Sweet Cherry Pie

Artform Home Plans
AFHP Design # 481.124.v2 KR
© 2012-2018 Art Form Architecture 603.431.9559
Sweet Cherry Pie
Lot 29 Stroudwater Preserve
Portland, ME
1
1/4"=1'-0" unless noted otherwise / Print @ 1:1
PDF created on: 7/19/2018, drawn by ACJ
Issued for: **Construction**

DRAWING NAME: SITE PLAN
 PROJECT NAME: LOT 29 LEVEL I MINOR RESIDENTIAL APPLICATION
 STROUDWATER PRESERVE
 CLIENT: STROUDWATER DEVELOPMENT PARTNERS, LLC
 KENNEBUNK, ME

First Floor Framing

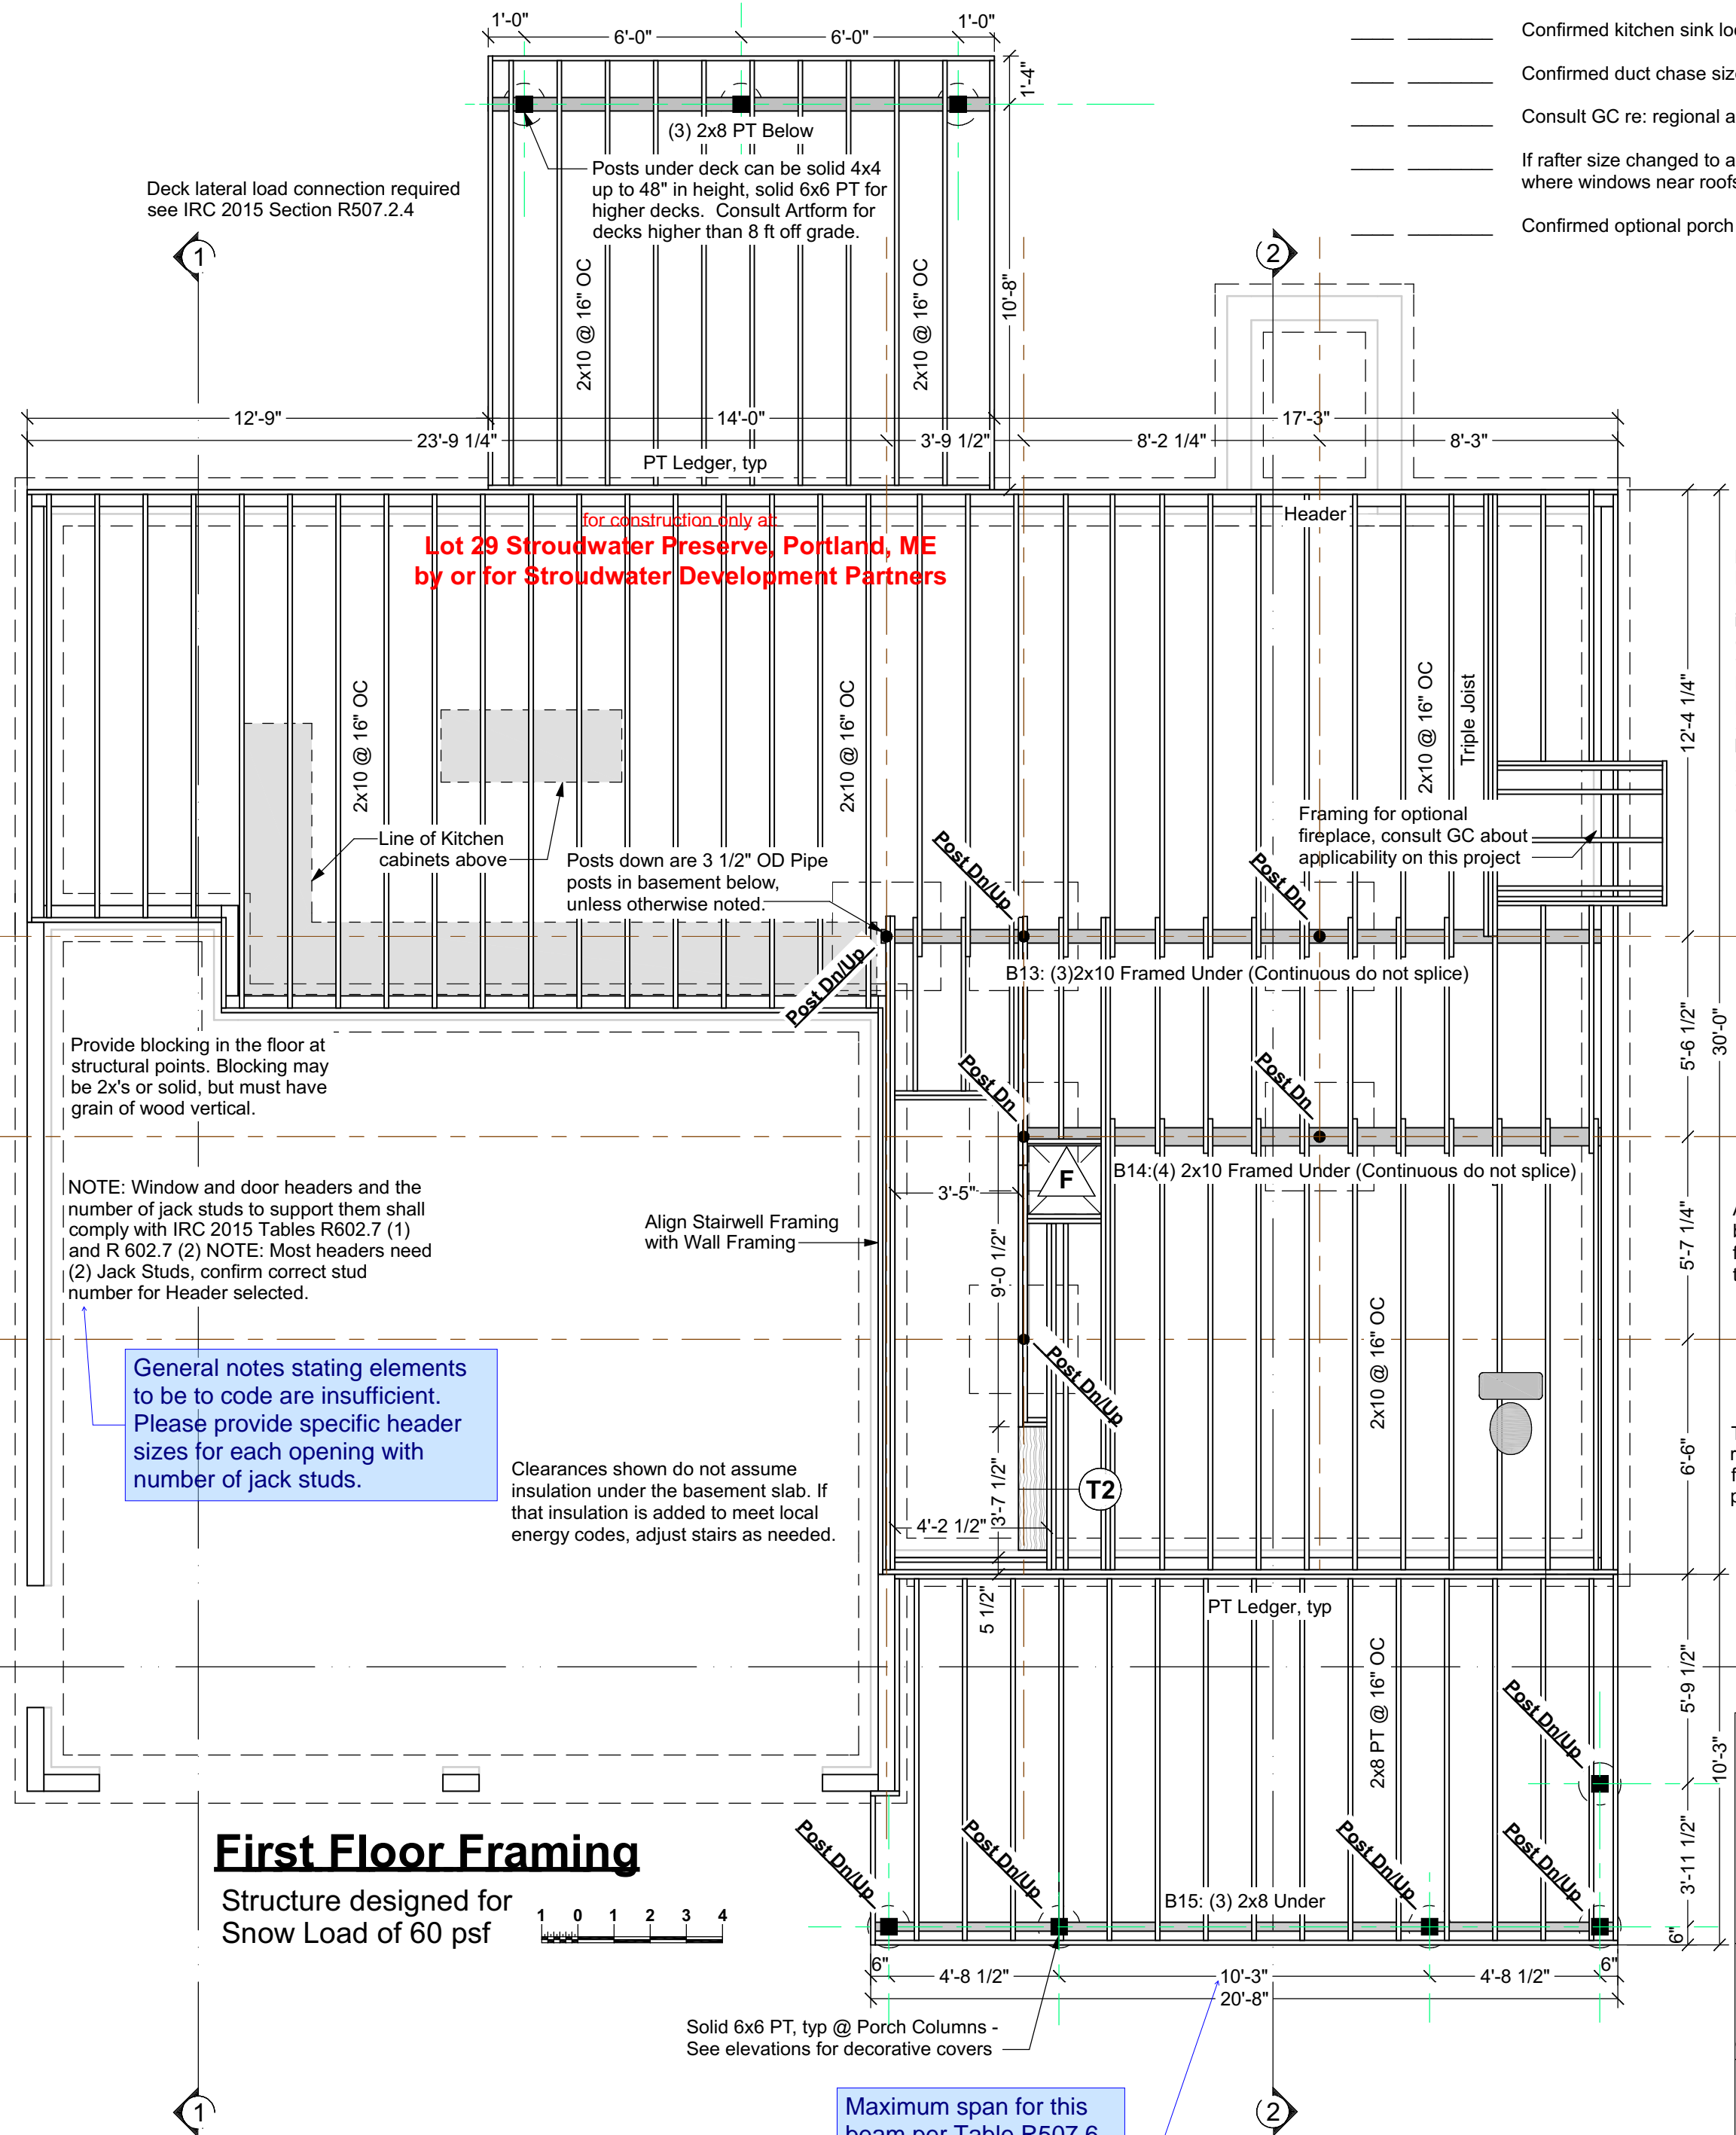
General notes stating elements to be to code are insufficient. Please provide specific header sizes for each opening with number of jack studs.

Provide a structural design report for each manufactured beam showing beam span with site specific applied loads and approved beam size, posts and connections. Or, provide stamp on plans by a State of Maine registered structural engineer.
